Suggested floor cropping & upper half removed
marked by X

L998-0026

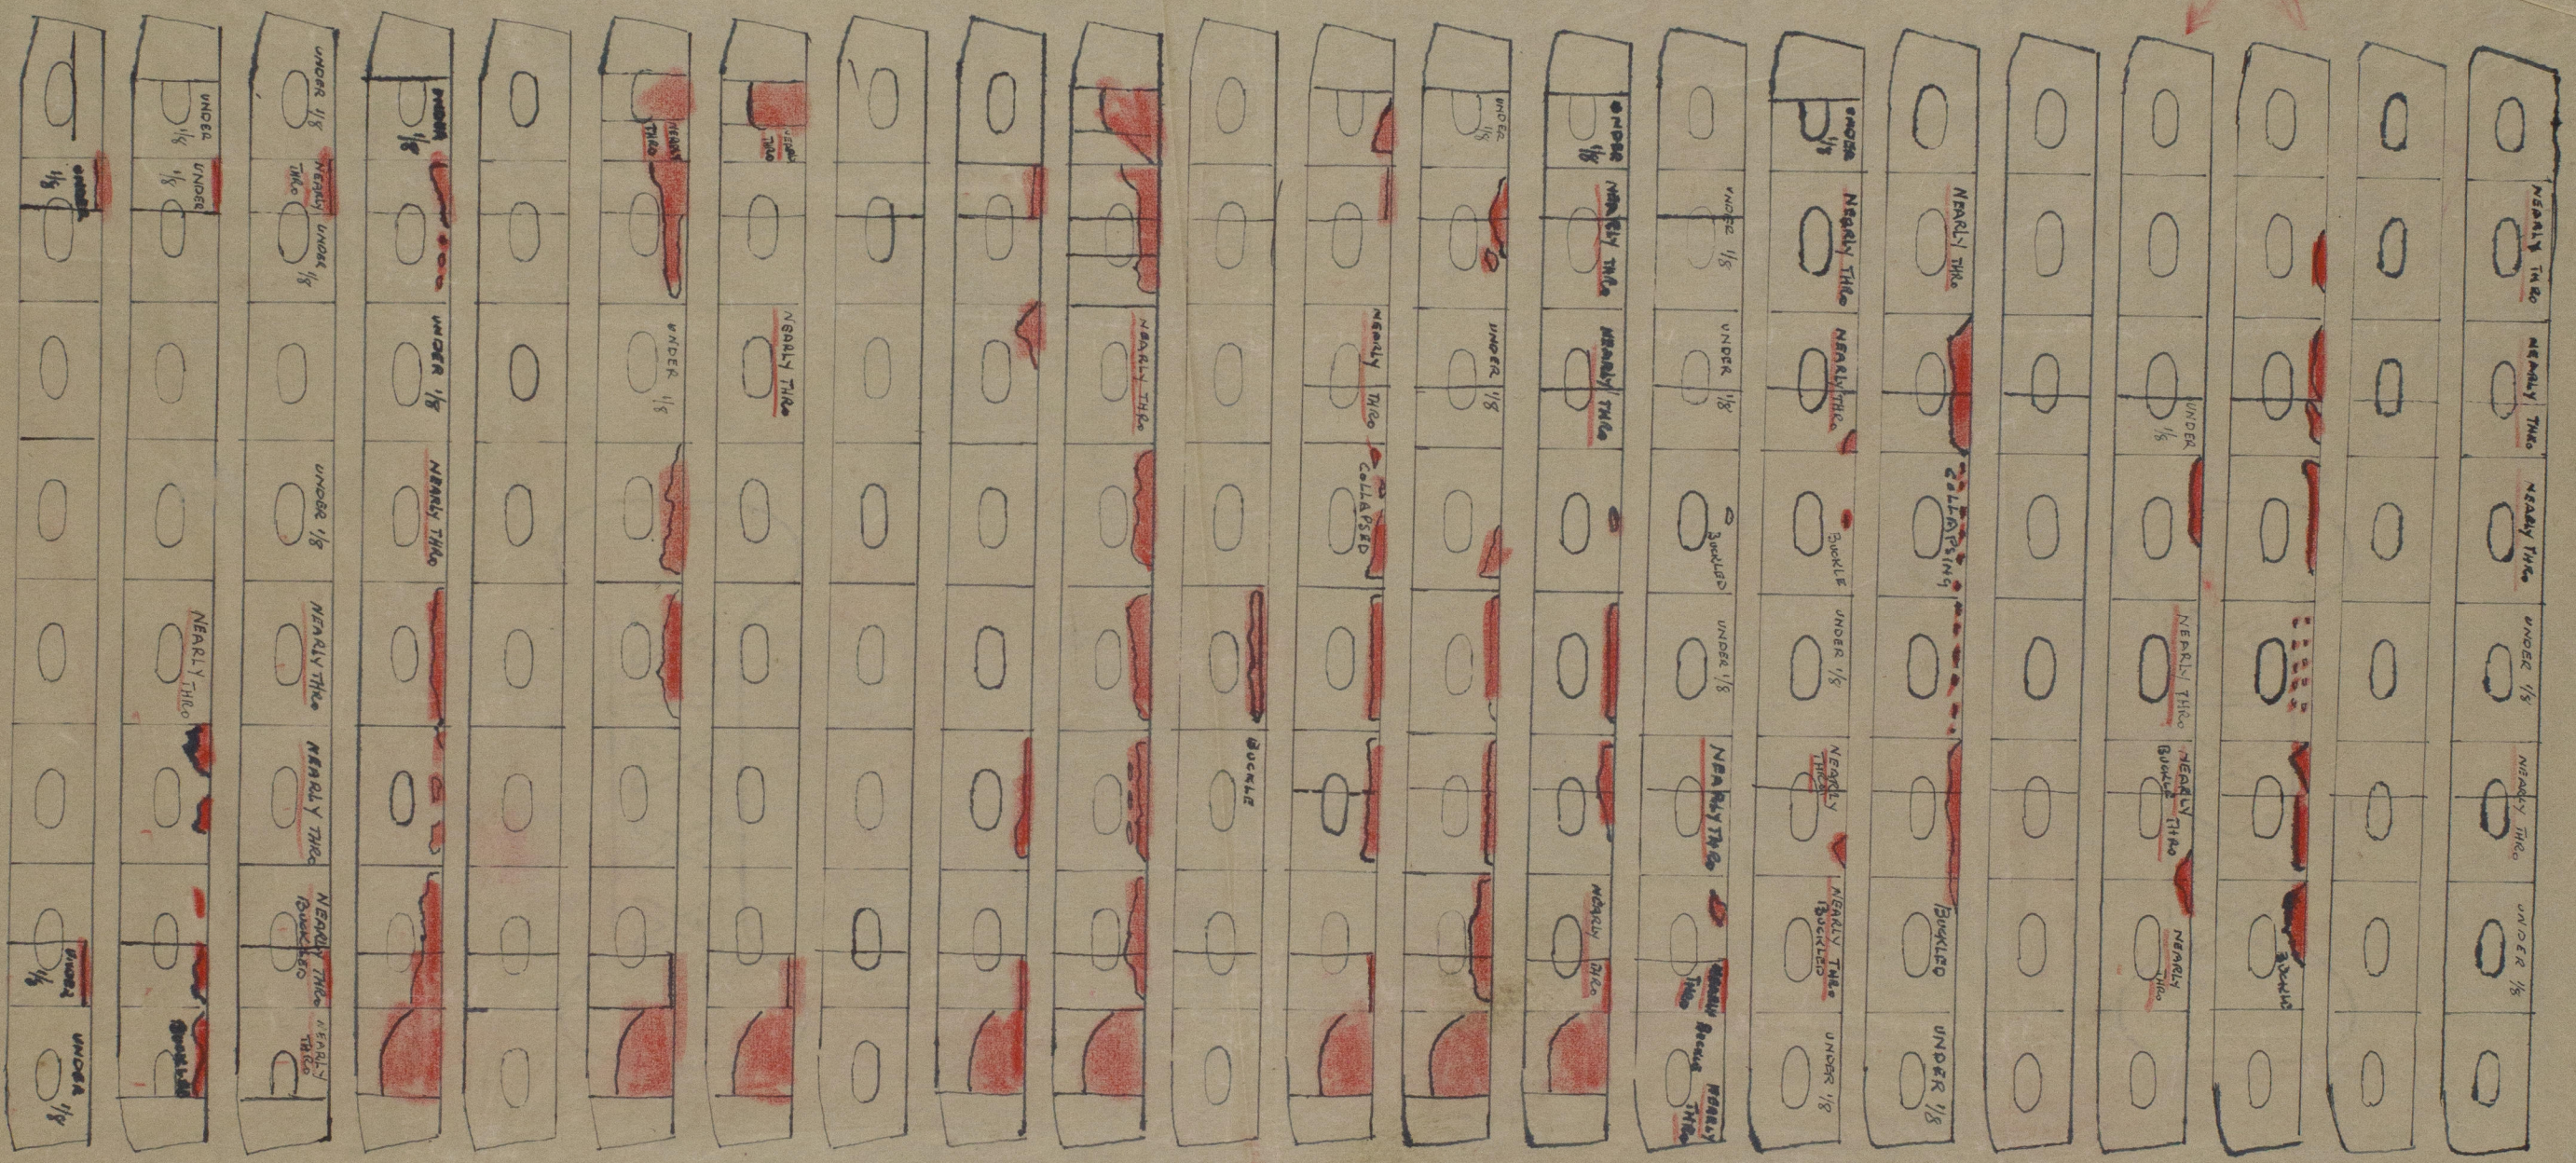
PARTS SHOWN IN RED COMPLETELY GONE. ORIGINAL INTERCOSTALS IN A
SIMILAR CONDITION TO THE FLOORS. TANKTOP NOT YET CLEARED BUT OBSERVED
TO BE LEAKING FROM THE TOP IN 5 PLACES.
